| Office Action Summary | Application No. 10/617,121 | Applicant(s) KOOKEN ET AL. | |

DETAILED ACTION

Claims 1-10 & 15-17 are rejected under 35 U.S.C. 103(a) as being unpatentable over Applicant Admitted Prior Art (AAPA) (fig. 2) in view of Patel US 6163073, further in view of Getter US 4772102.

FIG. 2
(PRIOR ART)

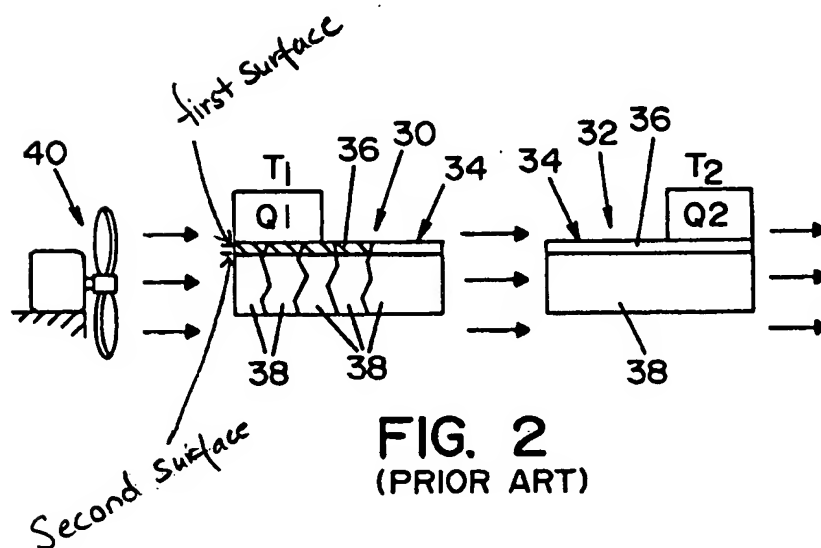
With respect to claim 1, AAPA teaches a heat dissipation platform for an output switch (Q1) of an inverter power source of an electric arc welder, said platform comprising a conductive plate (36) with first and second generally parallel surfaces (see, for example, locations marked on AAPA) and, said switch (Q1) being mounted on said first surface.

AAPA discloses a single switch mounted on a heat sink, except for an additional switch.

AAPA lacks a plurality of parallel heat pipes located between said surfaces and extending in a given direction.

With respect to claim 2, AAPA teaches a heat sink (30) of high heat conductivity material with a thin mounting plate (34) on said second surface and integral, parallel fins (38) protruding from said mounting plate (34) in a direction away from said second surface and extending in said given direction.

With respect to claims 3, AAPA teaches a fan (40) mounted on said platform to blow air toward said second surface (see, for example, location marked on AAPA).

With respect to claim 5, AAPA teaches a switch (Q1) mounted at a first location on said first surface and a first fan (40) blowing air toward said second surface at a said first location.

With respect to claim 15, AAPA teaches wherein said plate (36) comprises a first portion and a second portion.

With respect to claim 16, AAPA teaches wherein said first portion includes said first surface and said second portion includes said second surface (see, for example, locations marked on AAPA).

With respect to claim 17, AAPA teaches a heat dissipation platform for one output switch (Q1) of an inverter power source of an electric arc welder, said platform comprising a conductive plate (36) having first and second surfaces (see, for example, locations marked on AAPA), a switch (Q1) being mounted on said first surface at a first location.
